PROPOSED MARSTEL BULK LIQUID FUEL STORAGE FACILITY, MAYFIELD (08_0130)

ENVIRONMENT PROTECTION AUTHORITY- COMMENTS ON THE PROPOSED MARSTEL BULK LIQUID FUEL STORAGE FACILITY, MAYFIELD (08_0130)

Figure Error! No text of specified style in document.-1: Difference in Max and Min Temperatures between NSW and San Francisco

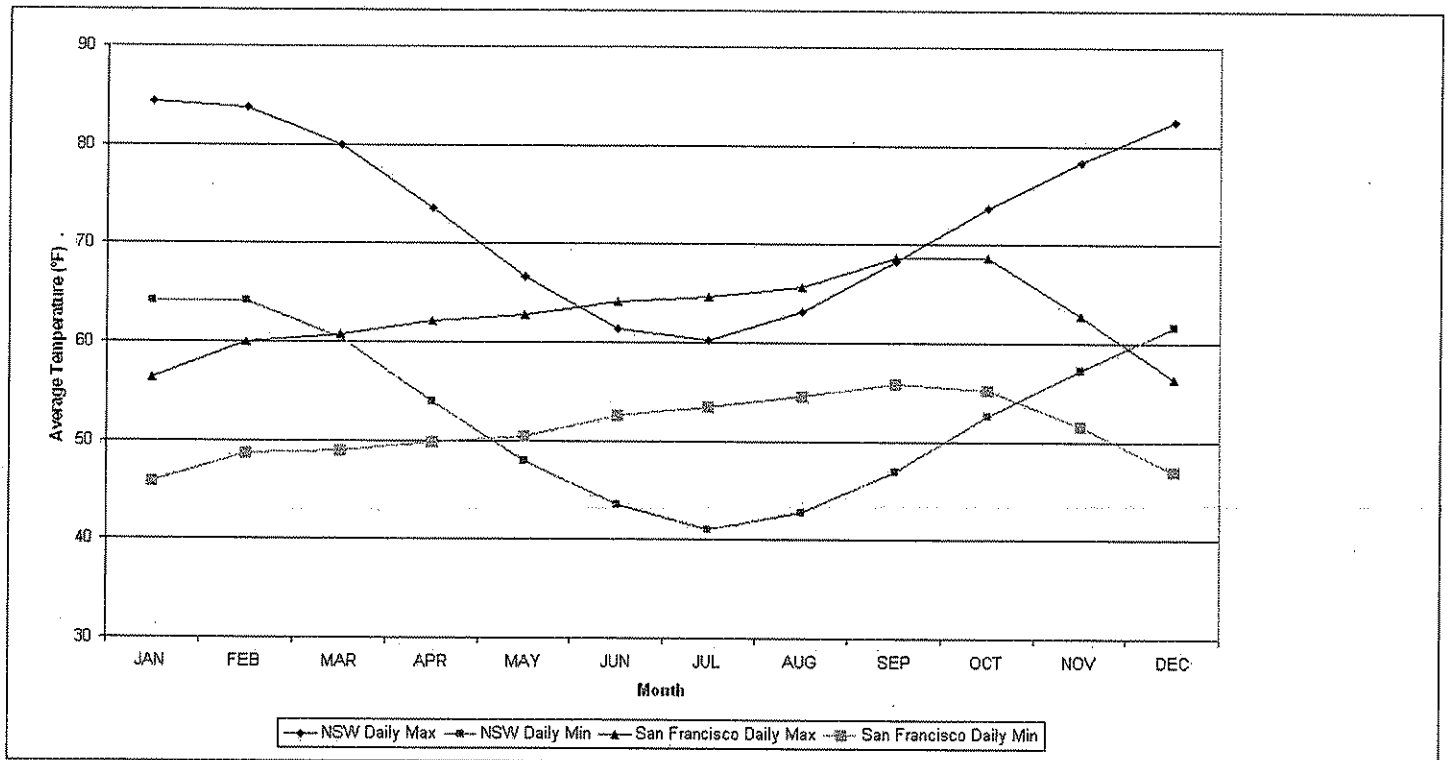
The EPA notes that the meteorological data used in the assessment is the default data set shipped with the software program for San Francisco. This is significantly different meteorological conditions to those expected at the proposed site.

The EPA has performed a comparison of meteorological conditions that should have been used in the assessment from those of San Francisco. The difference in monthly maximum and minimum temperature between NSW and San Francisco is presented in Figure Error! No text of specified style in document.-1.

By using San Francisco meteorological data, maximum emissions from the proposed tanks have been estimated to occur during winter and minimum emission have been estimated to occur in summer. This is the opposite of what would occur. However, as the emissions are from a low volatility liquid, the majority of emissions are from working loss and not from breathing loss.

Using the incorrect meteorological data in TANKS has resulted in incorrect emissions being estimated for the air quality assessment.

The EPA recommends that site specific meteorological data is used to assess the impacts of the proposed facility in a revised air quality assessment.

Figure Error! No text of specified style in document.-2: Difference in Solar Insulation Factor between NSW and San Francisco

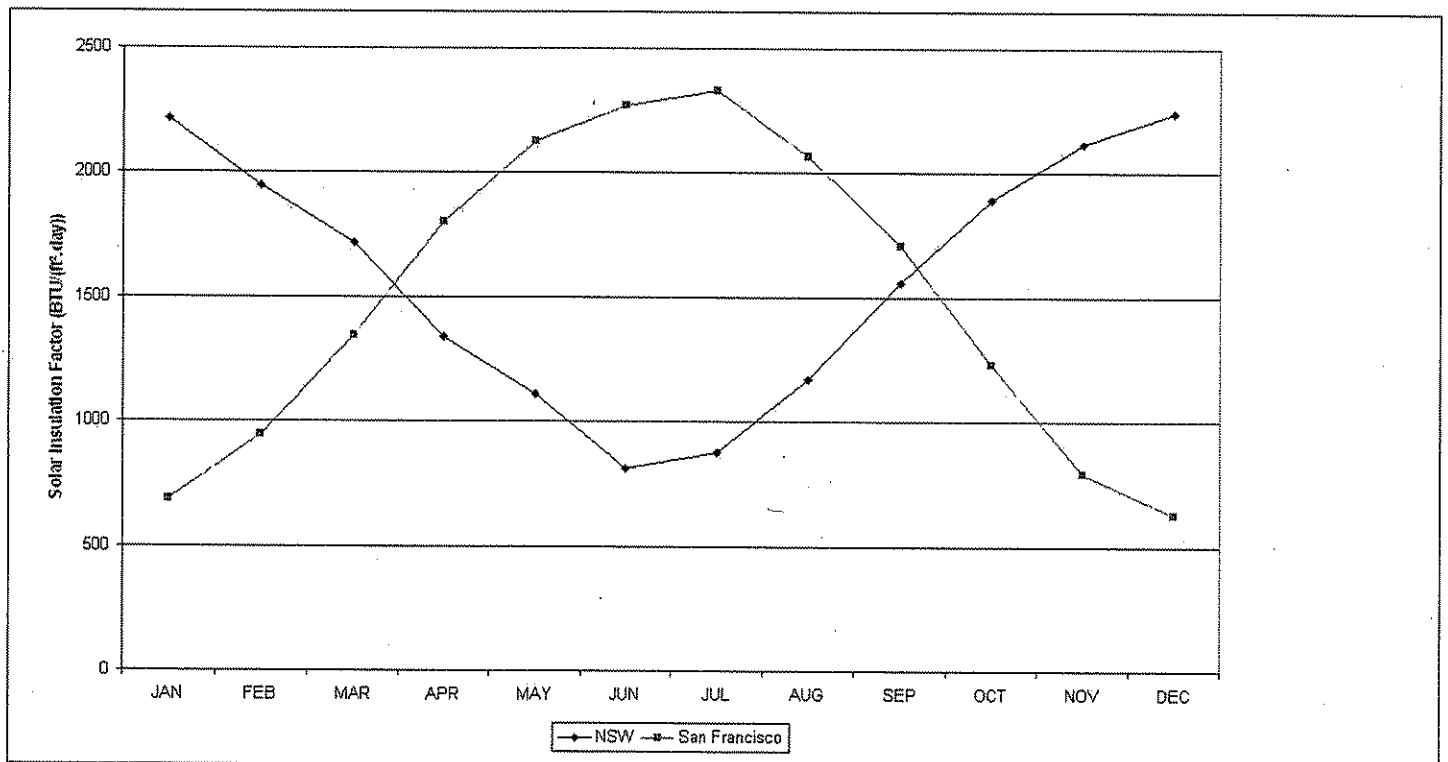
The difference in solar insolation factors between NSW and San Francisco is presented in Figure Error! No text of specified style in document.-2.
